City of Somerville

**TO:** Zoning Board of Appeals  
**FROM:** Planning, Preservation, & Zoning (PPZ) Staff  
**SUBJECT:** Clarendon Hill (34 North Street), 40B2020-001-R3  
**POSTED:** July 10, 2025

**RECOMMENDATION:** Insubstantial Change (Revision to Comprehensive Permit)

*Proposed Phasing Plan - Sheet G202*

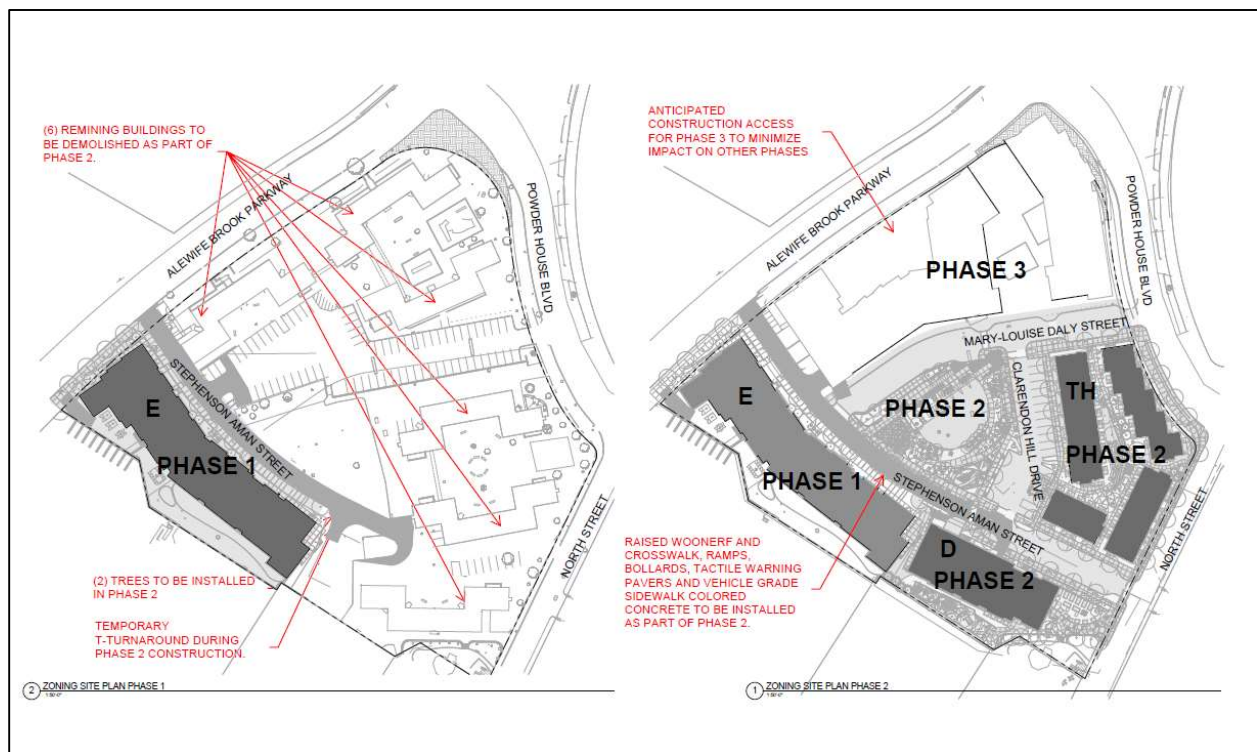
In the requested revision, the project is now proposed to have the following phasing - see the Zoning Phasing Plan – Sheet G-202 (Revised July 11, 2025) of the submittal:

- Demolition of three (3) existing buildings on Lot B1 (completed)
- Construction of Building E (nearly complete)
- Partial construction of Thoroughfare 1 to the eastern edge of Lot B1

- Demolition of six (6) existing buildings on Lots C1, D1, E1, E2, and F1
- Construction of central civic space, Building D, and the town houses
- Completion of three internal streets

- Construction of Buildings A & B

The most significant change in the phasing plans is that Buildings A & B, which are proposed to be 295 market-rate units, are now proposed to be part of a newly proposed Phase 3 of the project, instead of Phase 1. The reason for this change is a change in ownership of the property, with the market-rate developer Redgate dropping out of the project. (Conditions of approval are recommended to be changed accordingly below.)
